**State Historic Preservation
Division Approval Letter,
Dated August 8, 2012**

SUBJECT: Chapter 6E-42 Historic Preservation Review-
Archaeological Assessment Report for the Hawaiian Cement Quarry Expansion Project
Pulehunui Ahupua'a, Wailuku District, Island of Maui
TMK (2) 3-8-004:001 (por.)

**SUBJECT: Chapter 6E-42 Historic Preservation Review–
Draft Archaeological Assessment for the Hawaiian Cement Quarry
Pūlehu Nui Ahupua'a, Wailuku District, Island of Maui
TMK (2) 3-8-004:001 (por.)**

**ARCHAEOLOGICAL ASSESSMENT REPORT FOR HAWAIIAN
CEMENT QUARRY EXPANSION**

Figure 2. USGS Quadrangle Showing Location of Project Area (purple and red) and Various Plantation Camps Including Kihei Camp 3 and Camp 13

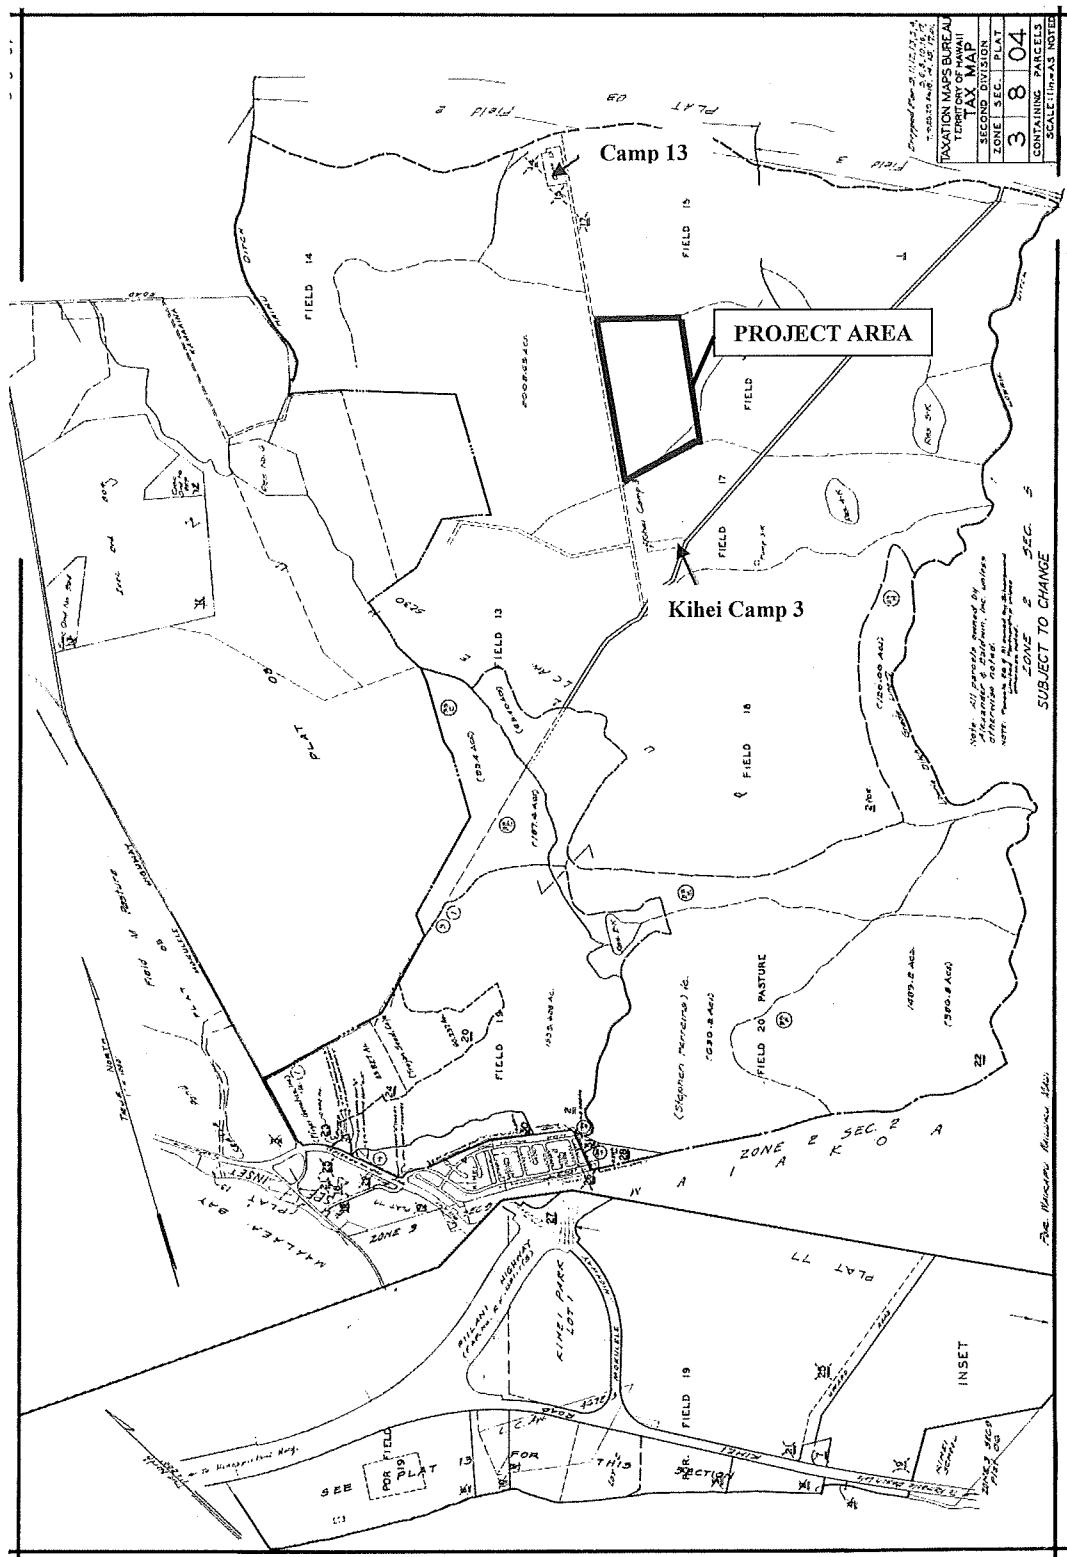
2. Introduction, page 9, first paragraph: please include a citation for the prior AA work in the nearby 42 acres mentioned here.
3. Figure 2, page 11: please provide a more detailed/closeup view (or a second map showing a portion, not all, of parcel 001) of the APE including the boundaries of Camps 3 and 13.

Figure 8. Sugar Cane Field Map Showing Project Area and Test Excavations (TR's 1-17 and BD's 1-2)
(note yellow highlighted area is the 8.8 acre section of the project area)

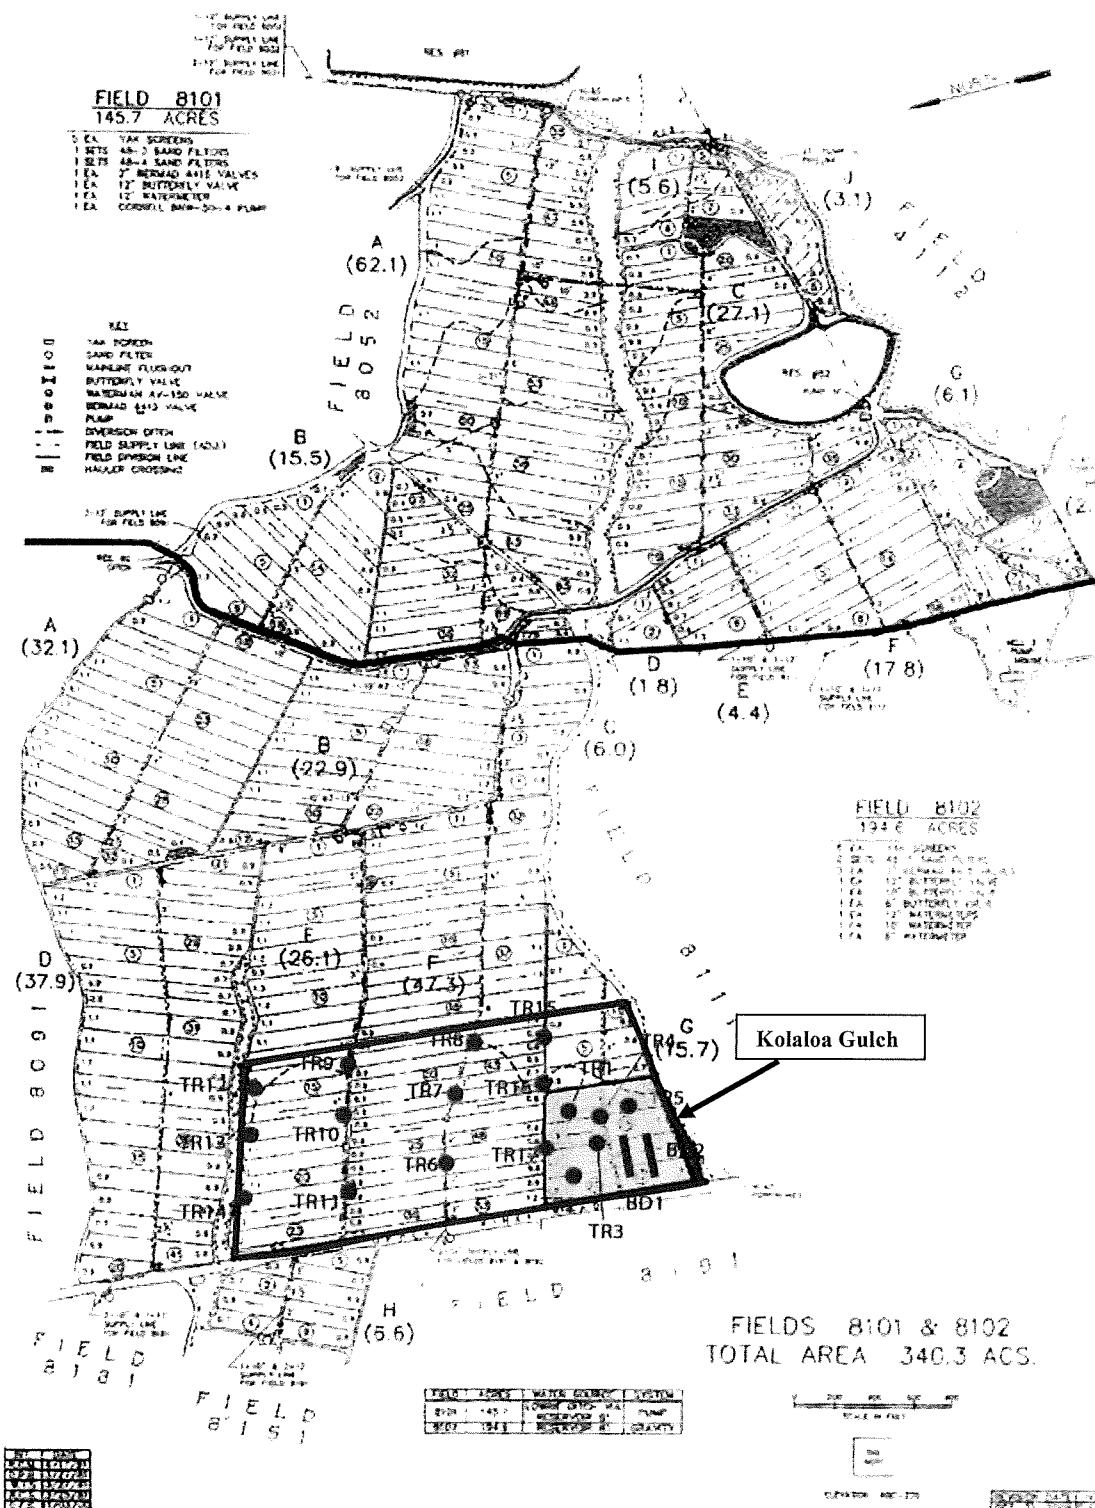
5. Previous Archaeology, page 17, second entry: please note that Sinoto and Pantaleo 1991 does not appear on figure 8; please include.
 - a. Page 18, ASH 2010 AA, end of page: please provide a citation for the information about adding marine shells as a soil conditioner to provide phosphorous.

Figure 9. Plan View Map Showing Previous Archaeological Studies near the Project Area

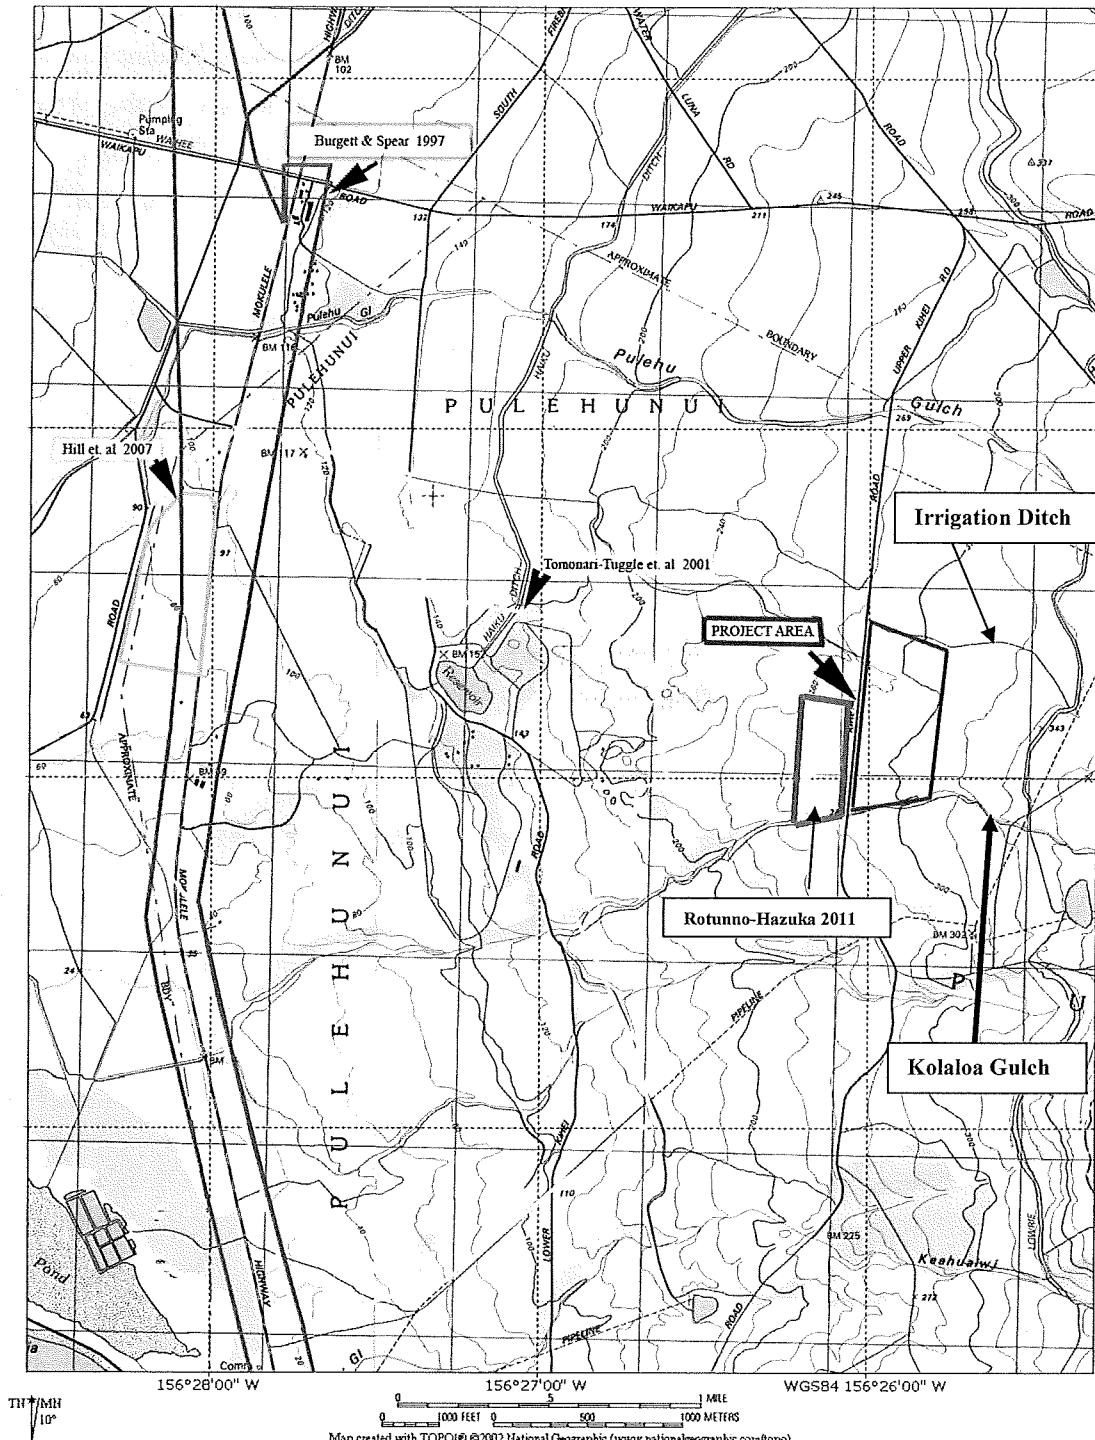
- 1) Please add the recent Cultural Surveys Hawaii archaeological surveys (2007 etc) to the map (Figure 9) and to the previous archaeology background text.
